CITY OF SANTA MARIA DEPARTMENT OF PUBLIC WORKS

UNION VALLEY PARKWAY EXTENSION STATE ROUTE 135 TO HUMMEL DRIVE

BID NO. 2012/02

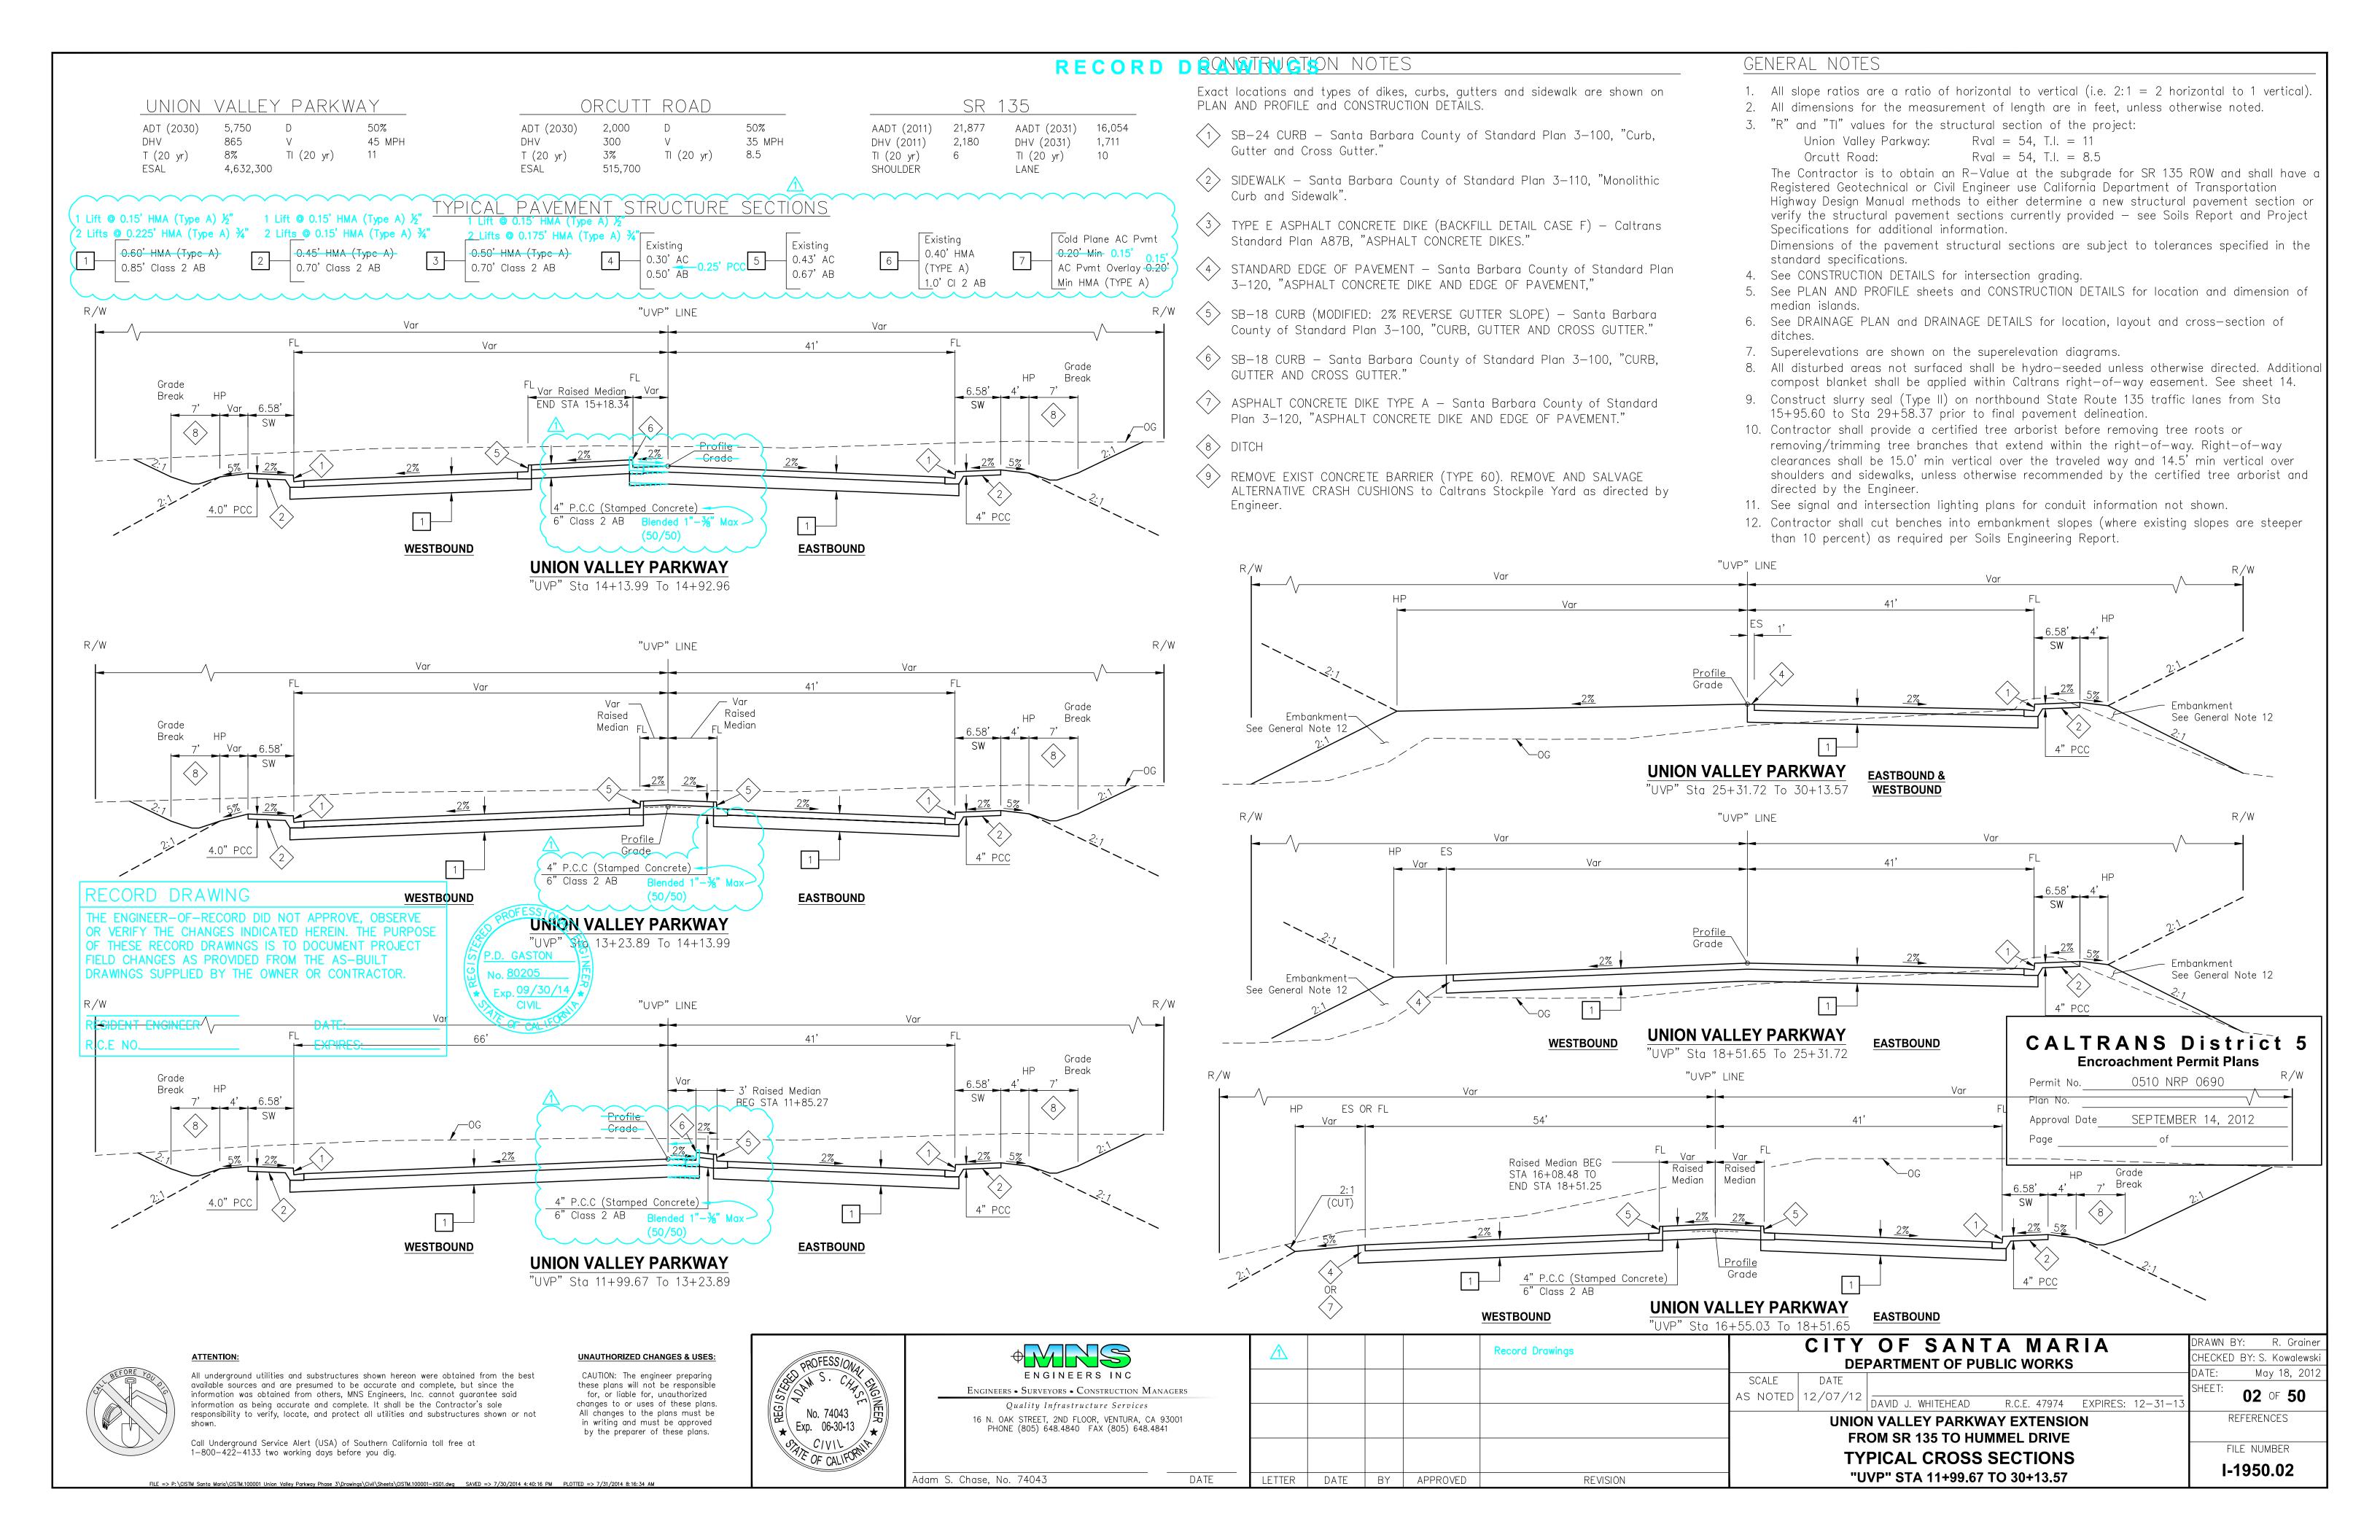
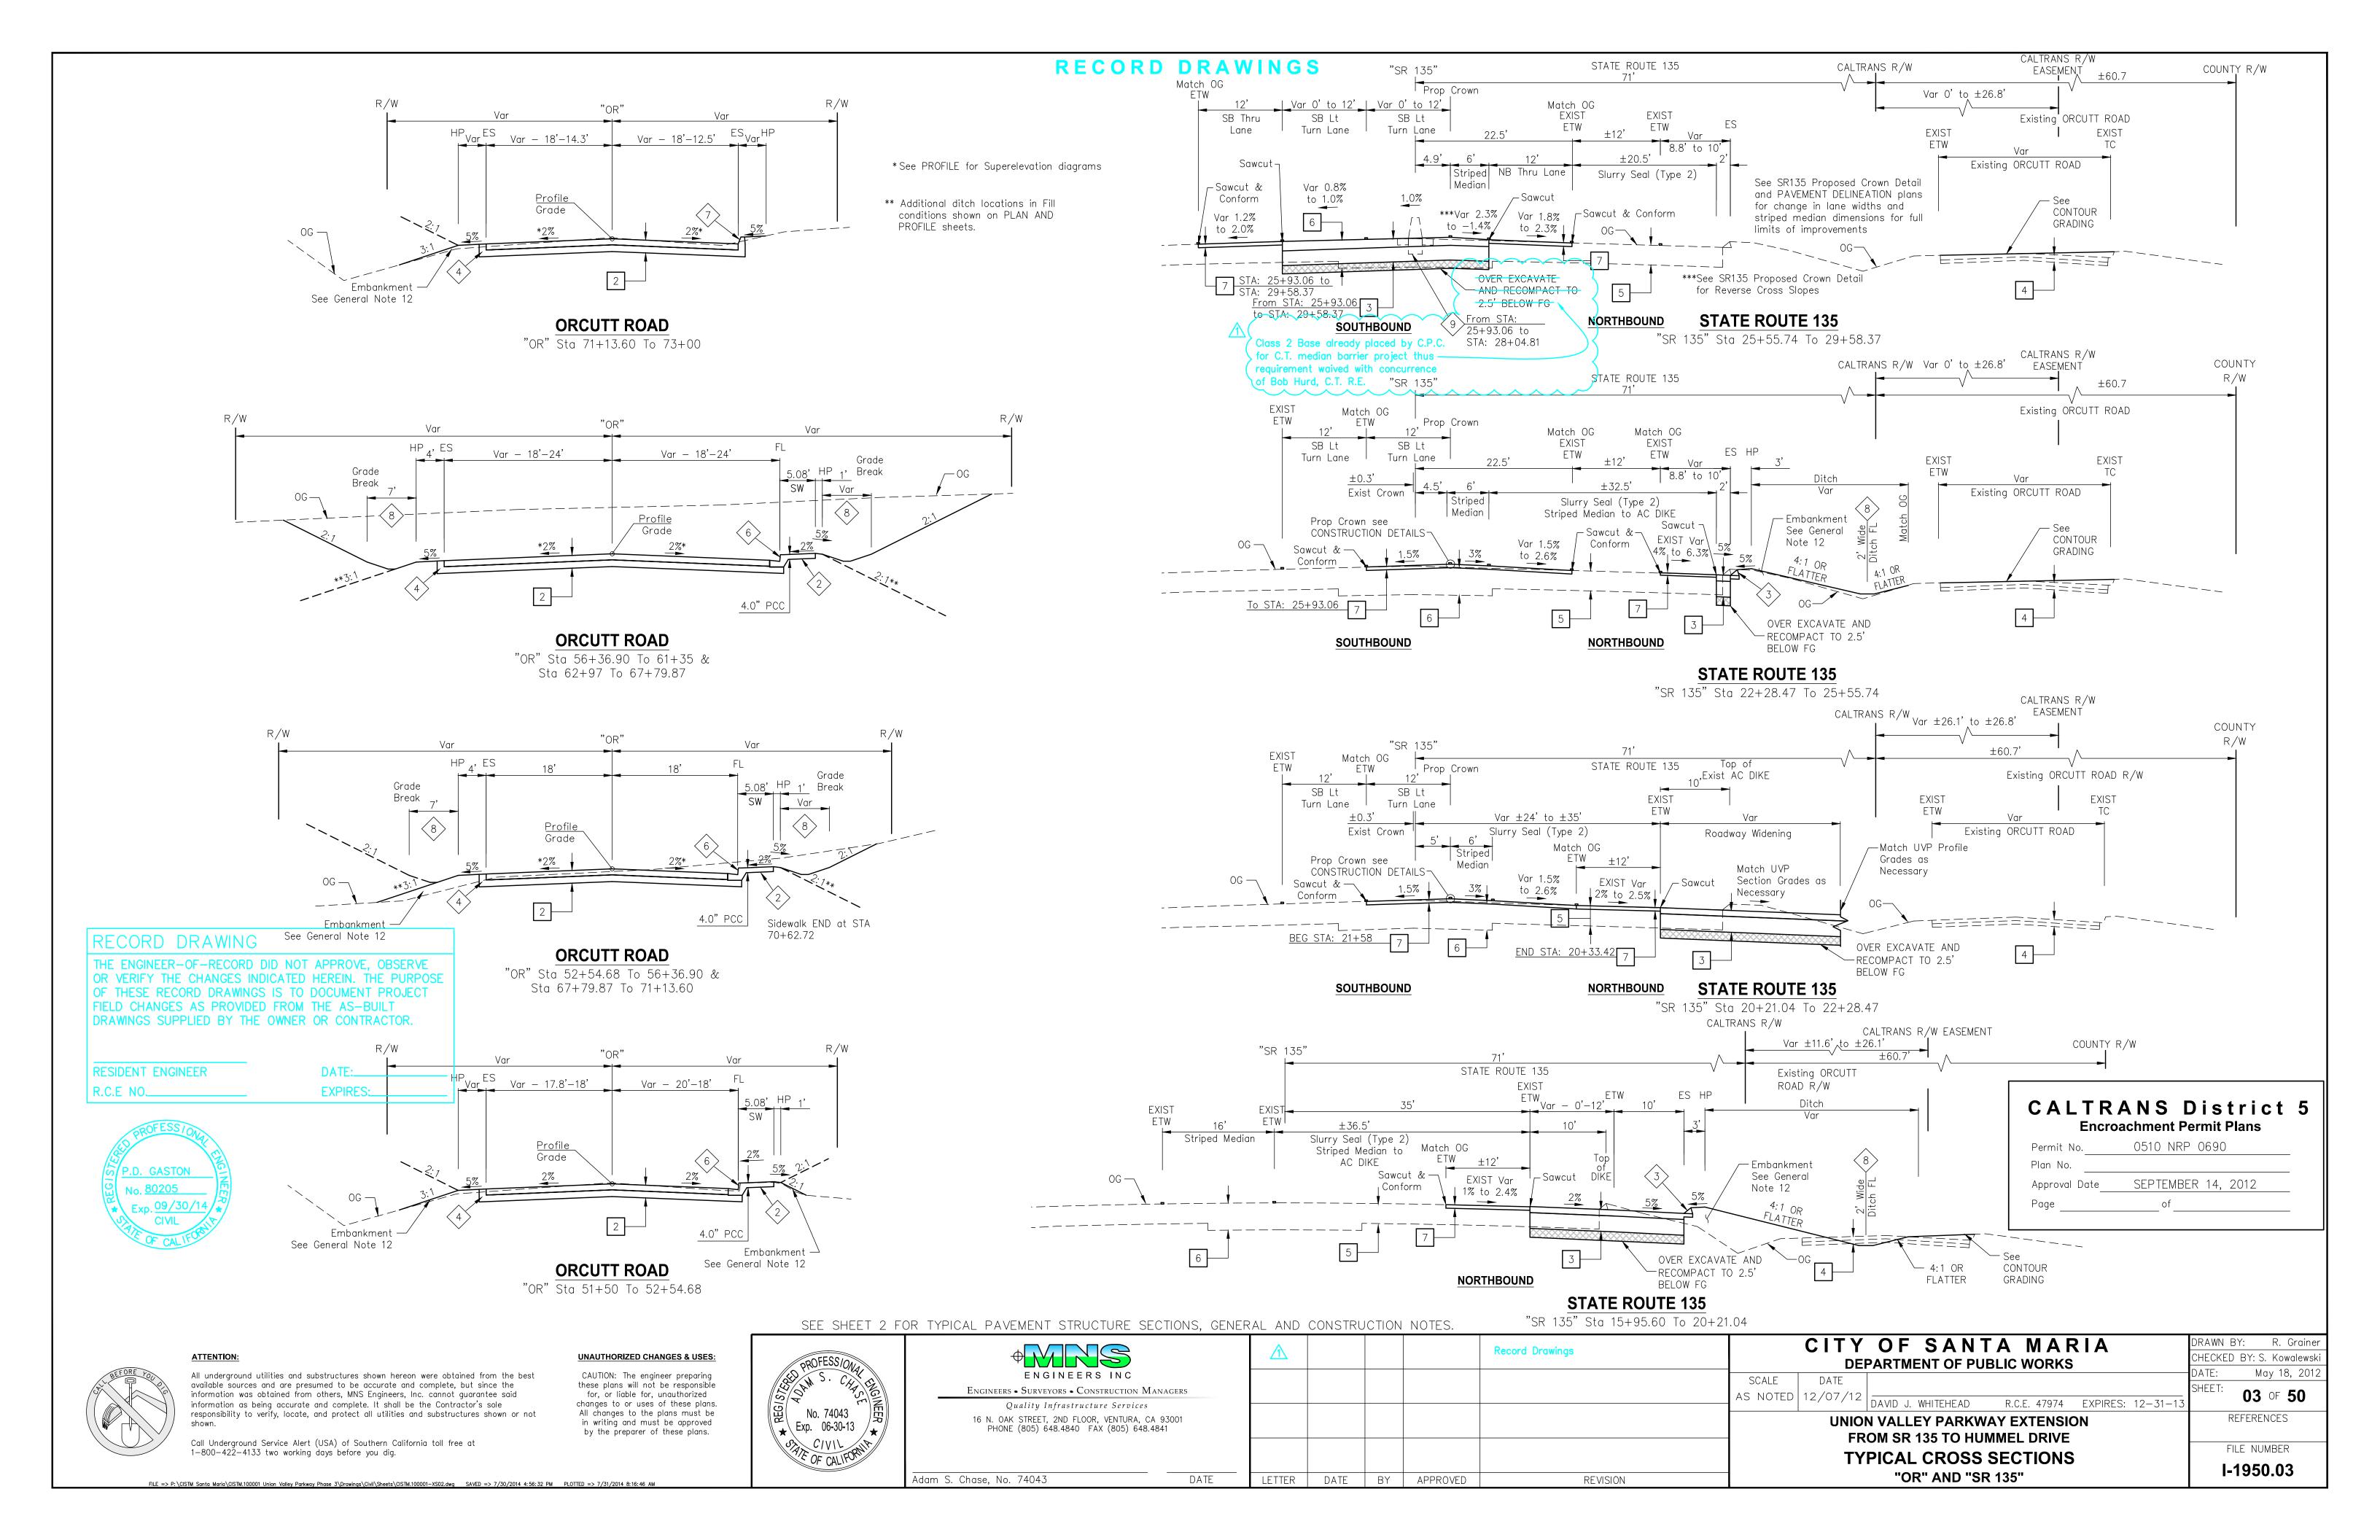
Stamped Concrete Survey Control Point *Additional manuments added please see	Crown/Grade Break shifted to Gutter Lip	**************************************		Median	O RT -43.75 UNION VALLEY PARKWAY 2	
Survey Control Point *Additional monuments added, please see C - Top of Cut F - T C - Till	The match Gutter Lip Curb FL	O: F N: 2151306.3422 E: 5831440.7188	CURB FL 79	Gutter Lip	HP HP	WATCH TO THE PROPERTY OF THE P
F - Toe of Fill · Direction of Ditch Flow	——————————————————————————————————————				$\begin{array}{cccccccccccccccccccccccccccccccccccc$	e c
	$\begin{array}{c ccccccccccccccccccccccccccccccccccc$	C C EC: 61+27.56	c c	$\frac{c}{c}$	R/W	
GENERAL NOTES 1. Refer to Drainage sheets for all drainage related items	e-(oh)	MATCH LINE -	SHEET 6		PROFESSIONAL THE ENGINEER-OF-RECORD OR VERIEV THE CHANCES	D DID NOT APPROVE, OBSERVE
including ditch layout and rock slope protection.	APN 107-250-011		SHEET O	APN	107-250-0135 P.D. GASTON OF THESE RECORD DRAWIN FIELD CHANGES AS PROVIDED BY THE	IGS IS TO DOCUMENT PROJECT DED FROM THE AS-BUILT HE OWNER OR CONTRACTOR
